Access Compliance Report

Public Rights-of-Way

| Intersection ID: 27431 | Main Street: BALLANTYNE COMMONS PY | Cross Street: RUSHMORE DR | Location: | NW |
| ADA ID: 68C2FBCABCA9 | Ramp Type: Perp | Initial Pass/Fail: Fail | Overall Compliance: No | Severity Score: 12.5 |

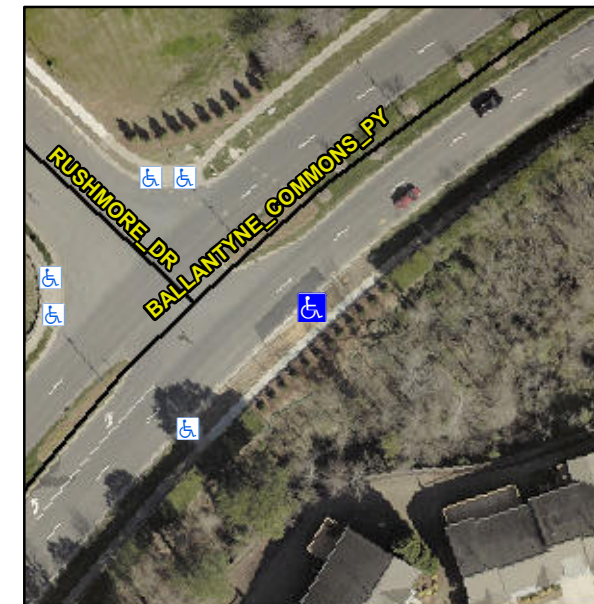
Not Found, R304.5.3

| Compliance | Description | Data | Compliance | Description | Data |
|------------|-----------------------|-------|------------|-----------------------------|------|
| Yes | Ramp Width (in) | 49.0 | No | Ramp XSlope (%) | 5.3 |

Remove & Replace Entire Ramp.
